ENGINEERING CHANGE NOTICE

Proj. ECN W016-77

EMW STORAGE W016

DWG H-2-80895 SHZ RD

ENGINEERING CHANGE NOTICE SKETCH

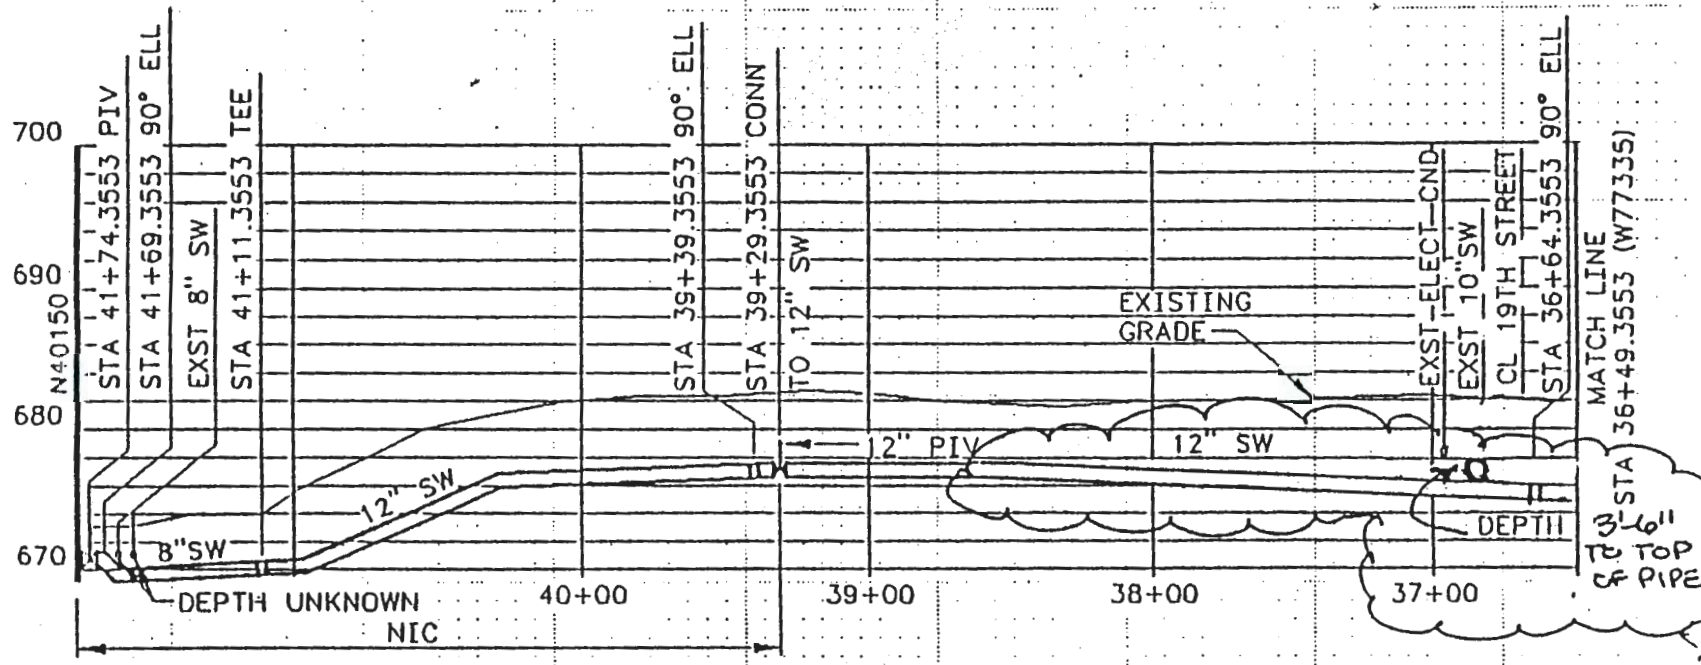
- 1) SLOPE NEW 12" SW LINE TO INTERSECT BELOW EXISTING 10" SW @ APPROX STA 37+00 AS SHOWN ON Pg 3
- 2) ADD NEW LOW POINT DRAIN VALVE ON 12" SW LINE JUST WEST OF 90° ELL LOCATED ON W77320 AS SHOWN ON Pg 4

ELEVATION OF NEW 12" SW LINE INTERCEPTS EXISTING 10" SW LINE @ SAME ELEV JUST WEST OF PFP FENCE AND SOUTH OF 19TH STREET

• SLOPE NEW 12" SW TO INTERSECT BELOW EXISTING 10" SW @ APPROX STA 37+00

NOTE: • HORIZONTAL STATIONING TOLERANCE SHALL BE ±0.1 FEET FOR NEW SW LINE.
